South San Joaquin Irrigation District

ADDENDUM NO.1

PROJECT: SSJID-25002-Lateral W190dd3dd to We Pipeline Connection Project

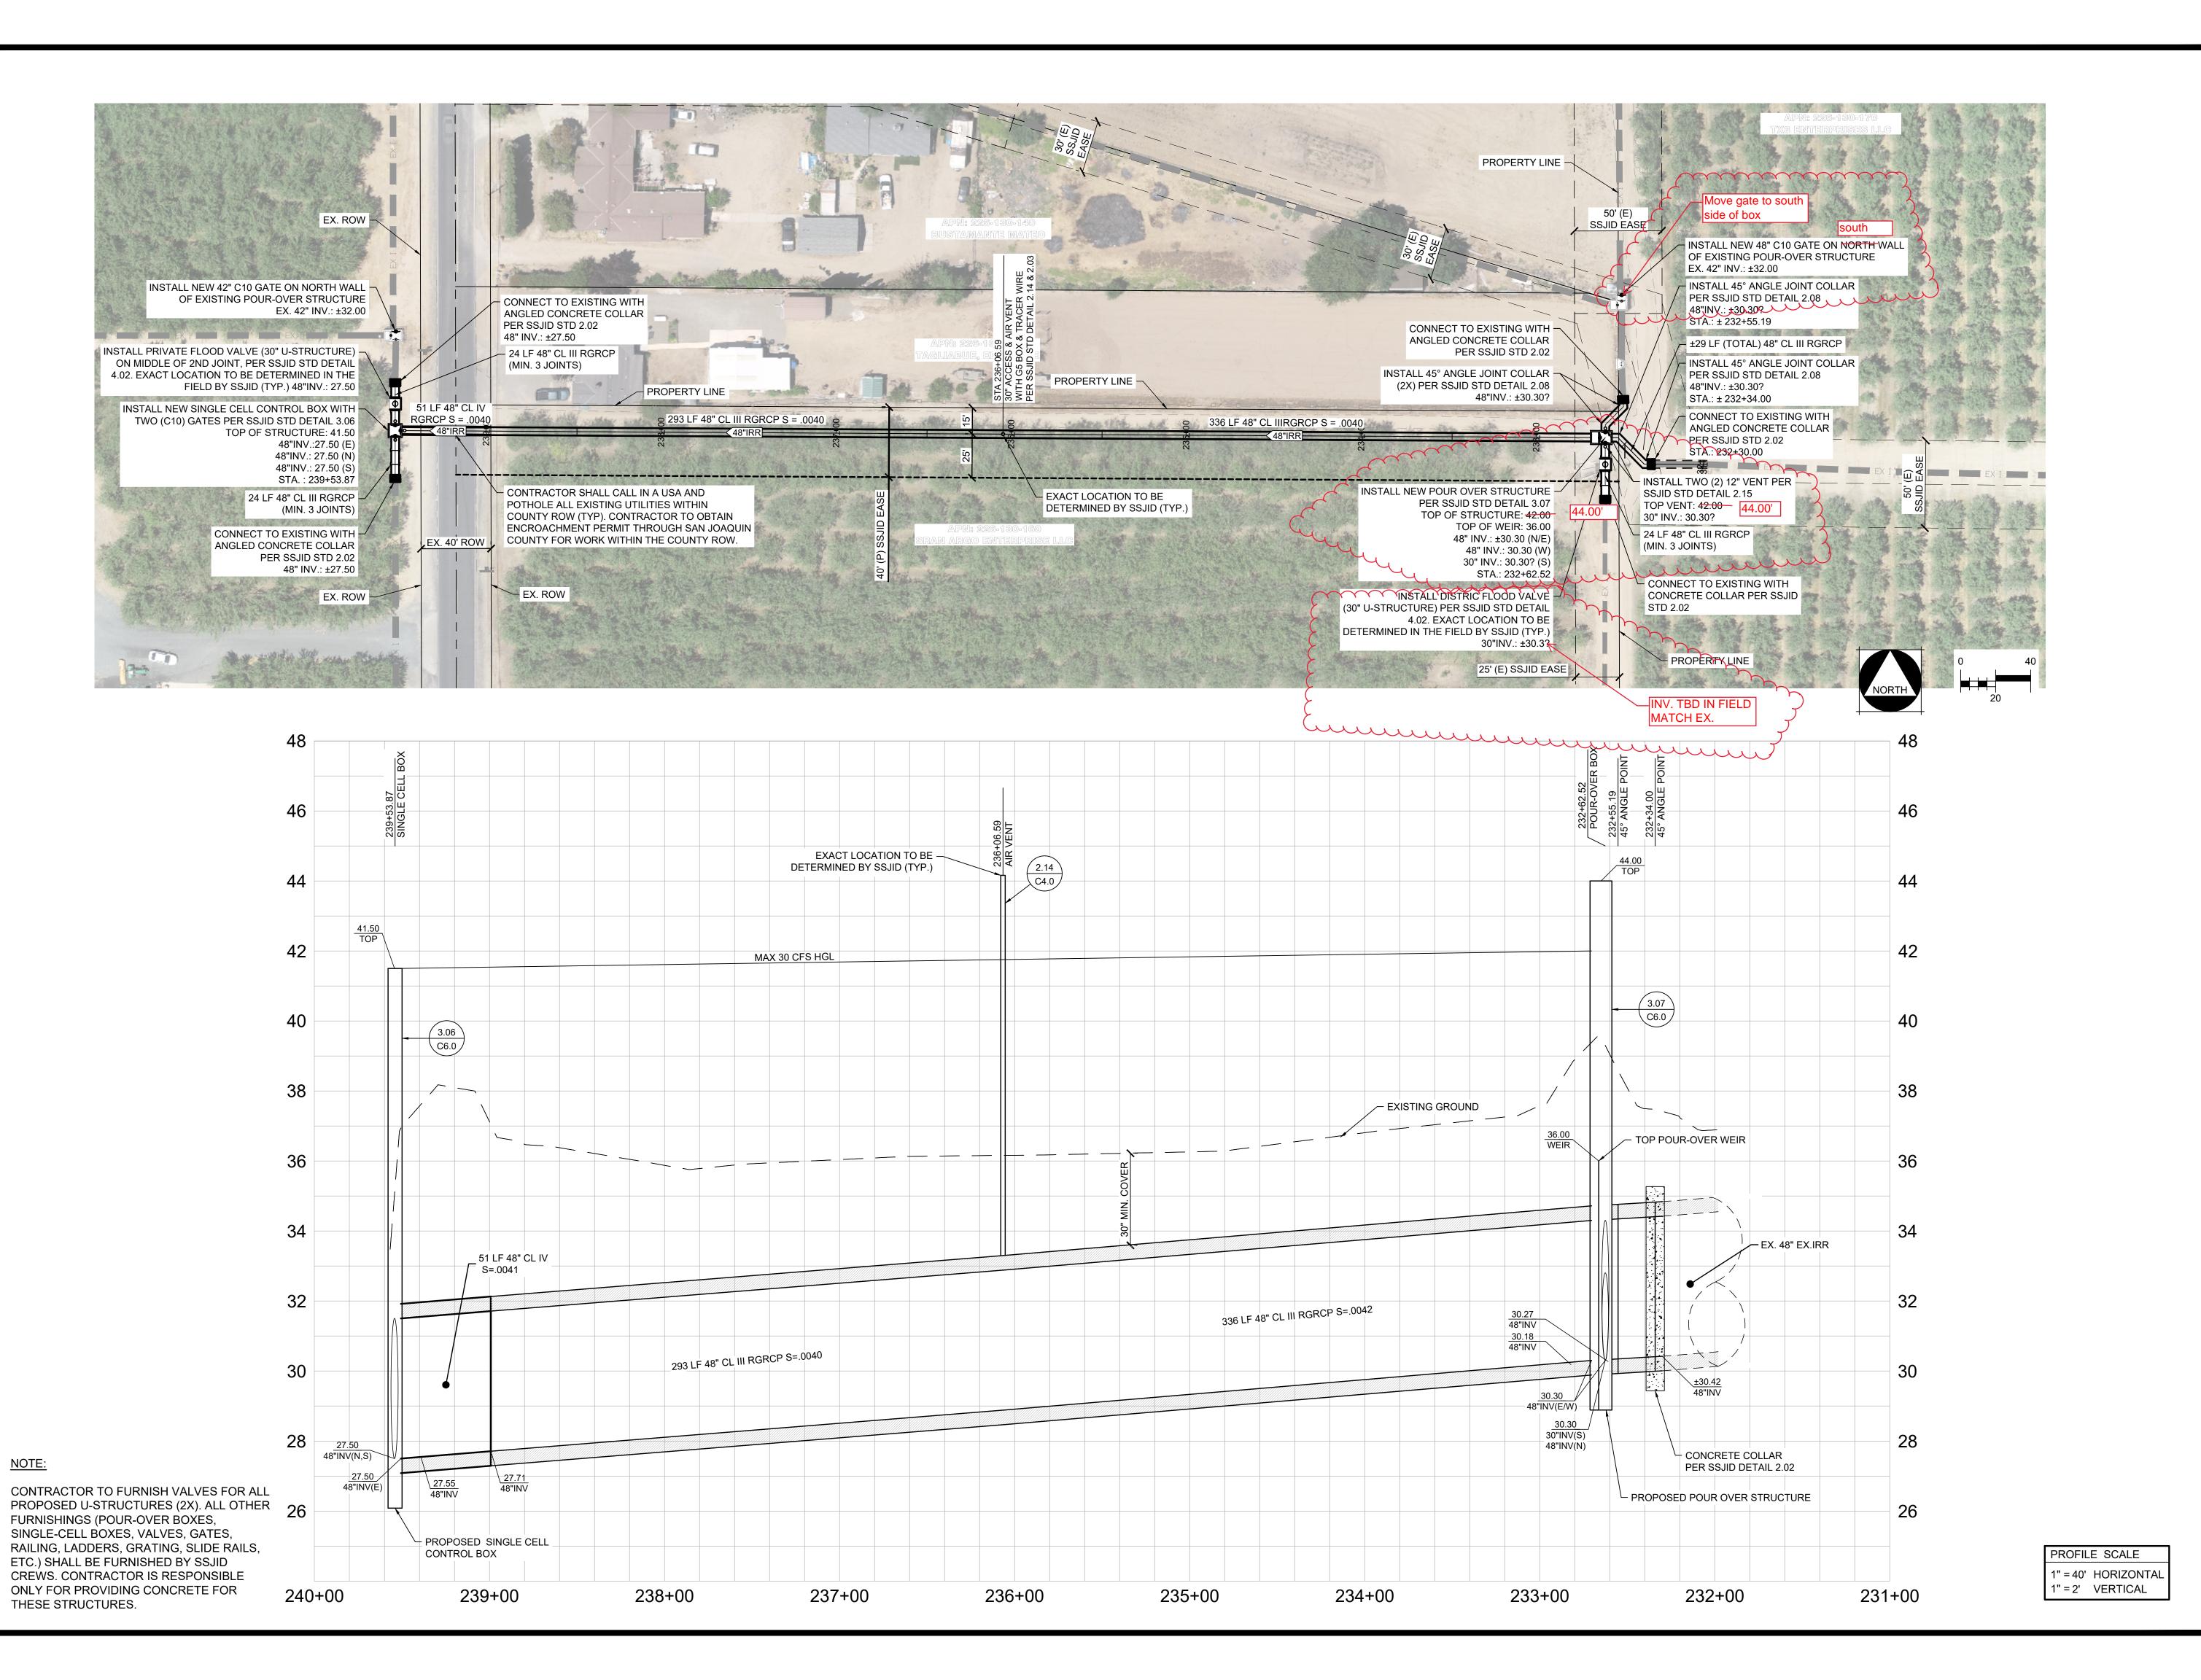
6) REVISION: Sheet C13.0

Revised Sheet C13.0, top of vents and top of control box are to be 44.00' at the proposed control box at Sta. 232+62. Existing 30" pipe invert is to match existing and to be determined in the field. Proposed 48" C-10 Waterman Gate at existing control box at Lateral W Sta. 233+50 is to be installed on the south wall.

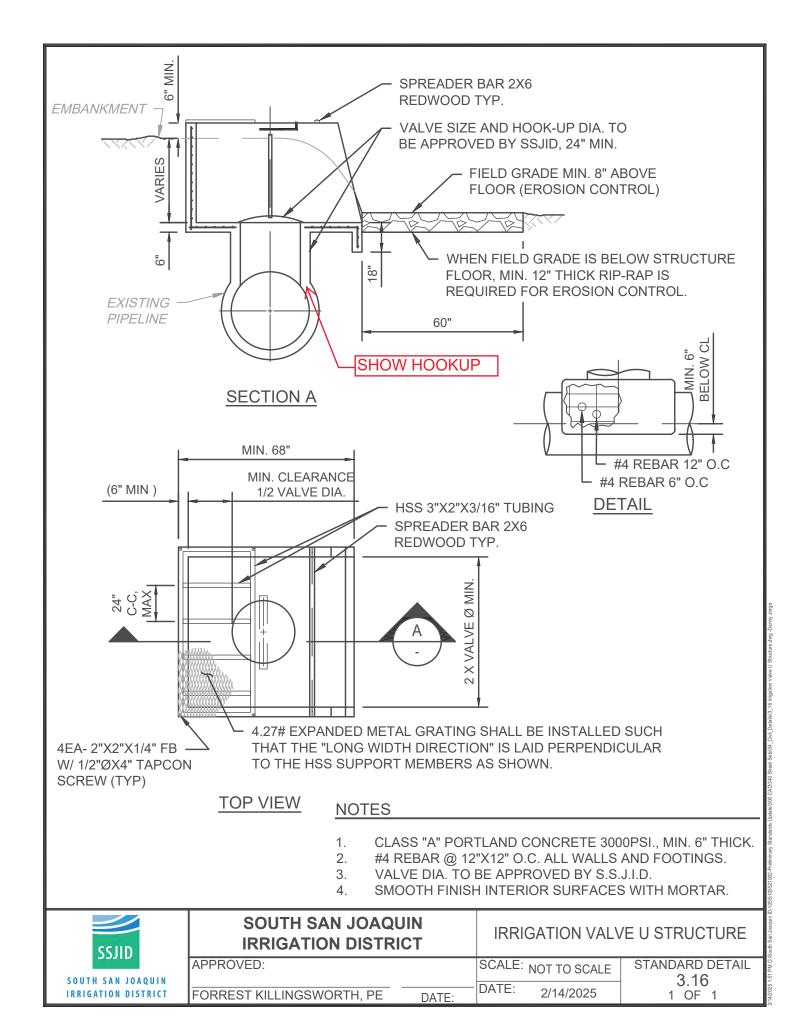
4) REVISION: SWPPP Sheet C16.0

Revision to sheet C16.0 of the plans. Revised notes, revised location of designated BMP areas to be within SSJID easement near Veritas Rd. Controlled construction entrances are required on any access road adjacent to any paved county road. A designated entrance/outlet tire wash is not required. The contractor is responsible for cleaning any track-out onto county right of way. There are no known drainage inlets within the construction area. Straw wattle is only required at the perimeter of the designated laydown and concrete washout area.

Replace:

"CONTRACTOR SHALL BE RESPONSIBLE FOR PREPARATION, COMPLETION, AND SUBMISSION OF THE STORM WATER POLLUTION PREVENTION PLAN (SWPPP) TO THE STATE WATER RESOURCES CONTROL BOARD IN ACCORDANCE WITH THE MOST CURRENT NPDES CONSTRUCTION GENERAL PERMIT REQUIREMENTS. CONTRACTOR SHALL ALSO BE RESPONSIBLE FOR OBTAINING THE WASTE DISCHARGE IDENTIFICATION (WDID) NUMBER FOR THIS PROJECT. THIS WORK SHALL BE INCLUDED IN THE CONTRACTOR'S SCOPE OF WORK AND SHALL NOT BE PERFORMED BY SSJID."

With:

"THE DISTRICT HAS SUBMITTED A STORM WATER POLLUTION PREVENTION PLAN (SWPPP) AND HAS OBTAINED A WDID NUMBER (WDID# 5S39C409574). THE CONTRACTOR IS RESPONSIBLE TO EXECUTE AND CLOSE THE PERMIT INCLUDING MONITORING AND REPORTING AS WELL AS BMP INSTALLATION AND MAINTENENANCE."
